**ZONING AMENDMENT
& SUBDIVISION STAFF REPORT****Date: January 7, 2016****APPLICANT NAME**

E Square, LLC

E Square Subdivision

LOCATION2724 Old Shell Road and 104 & 106 Bay Shore Avenue
(Northeast corner of Old Shell Road and Bay Shore Avenue).**CITY COUNCIL
DISTRICT**

SITE PLAN

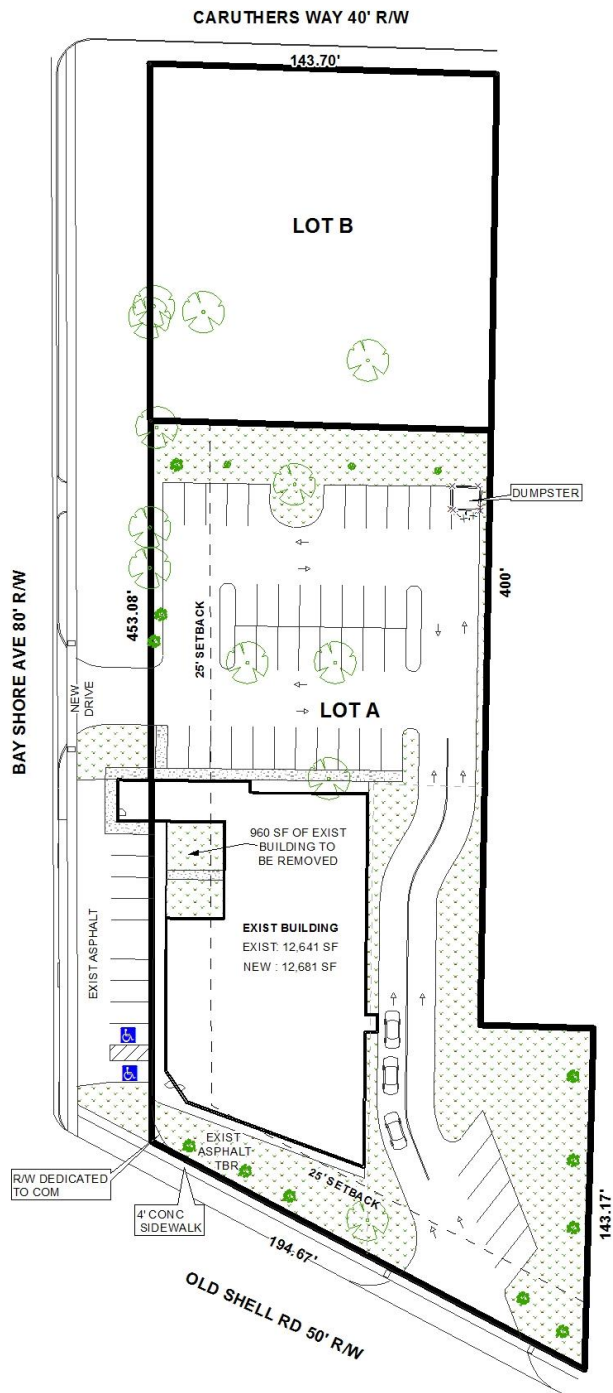
While Zoning approval is not site plan specific, it should be noted that the dumpster depicted on the site plan for Lot A is within the 10-foot residential buffer, thus it must be relocated elsewhere on the site.

It should also be noted that a total of 52 parking spaces are shown, but that only 43 will actually be on private property: the remainder are within the right-of-way of Bay Shore Avenue. Given that a new parking area will be built, full compliance with the parking and site lighting requirements of the Zoning Ordinance should be required.

A proposed drive-through is shown on the site plan. An order station is not depicted, however the pick-up window is shown. If an order station will be provided, the applicant must ensure adequate queuing space between the property line and the order station, and between the order station and the pick-up window.

Regarding access, the site plan depicts one new curb-cut to Old Shell Road and one new curb-cut to Bay Shore Avenue for Lot A. An existing continuous curb-cut along Old Shell Road is proposed to be closed. Another existing nearly continuous curb-cut along Bay Shore Avenue is proposed to remain open, due to the presence of existing parking spaces that the applicant wishes to retain. No development is shown on proposed Lot B, thus no proposed curb-cuts are depicted.

The 25-foot minimum building setback is depicted along Old Shell Road and Bay Shore Avenue, but is not depicted for Lot B along Caruthers Way. The plat should be revised to depict the minimum building setback line along all street frontages, adjusted for any required dedication.

The existing building on proposed Lot A will be reduced in size from 12,641 square feet to 11,681 square feet. A small portion of the building that will remain is located within the right-of-way for Bay Shore Avenue. Per conditions placed upon previous Subdivision approvals, a condition should be required that the applicant either remove that portion of the existing structure that extends into the right-of-way of Bay Shore Avenue, or obtain approval of a Right-of-Way Use Agreement for the building (non-utility for the building) and for the parking by the City of Mobile.

Lot A should be limited to one curb-cut to Old Shell Road, one new curb-cut to Bay Shore Avenue, and allowed to retain the existing nearly continuous curb-cut to Bay Shore Avenue (subject to obtaining the necessary approvals for use of the right-of-way for parking). As Caruthers Way leads to Randolph Street, which is primarily residential, Lot B should be limited to one curb-cut to Bay Shore Avenue and denied access to Caruthers Way. Any modifications to existing curb-cuts that will remain, and the size, design and location of any new curb-cuts are to be approved by Traffic Engineering and comply with AASHTO standards.

- 1) Dedication along Caruthers Way to provide 25-feet from the centerline;
- 2) Depiction of the 25-foot minimum building setback from all street frontages;

- 3) Revision of the lot sizes to reflect dedication;
- 4) Provision of corner radii in compliance with Section V.D.6. of the Subdivision Regulations;
- 5) Placement of a note on the Final Plat stating that Lot A is limited to one curb-cut to Old Shell Road and one new curb-cut to Bay Shore Avenue, and that Lot B is limited to one curb-cut to Bay Shore Avenue and is denied access to Caruthers Way, with the size, design and location of all curb-cuts to be approved by Traffic Engineering and comply with AASHTO standards.

- 6) Removal of any unused curb-cuts and the restoration of curbing, grass and sidewalks;
- 7) The existing parking and curb-cut access to Bay Shore Avenue, within the right-of-way, subject to the obtaining of a Right-of-Way use agreement;

- 8) The existing building within the Bay Shore Avenue right-of-way to remain only if a non-utility Right-of-Way use agreement is secured;
- 9) Compliance with Engineering comments (*The following comments should be addressed prior to submitting the FINAL PLAT for acceptance and signature by the City Engineer: A. Provide all of the required information on the SUBDIVISION PLAT (i.e. signature blocks, signatures, certification statements, written legal description, required notes, legend, scale, bearings and distances) that is required by the current Alabama State Board of Licensure for Professional Engineers and Land Surveyors. B. Provide and label the monument set or found at each subdivision corner. C. Add a signature block for the Owner, Notary Public, Planning Commission, Traffic Engineer, and City Engineer. D. Provide the Surveyor's Certificate and Signature. E. Provide the Surveyor's, Owner's (notarized), Planning Commission, and Traffic Engineering signatures. F. Add a note to the SUBDIVISION PLAT stating that a Land Disturbance permit will be required for any land disturbing activity in accordance with Mobile City Code, Chapter 17, Storm Water Management and Flood*
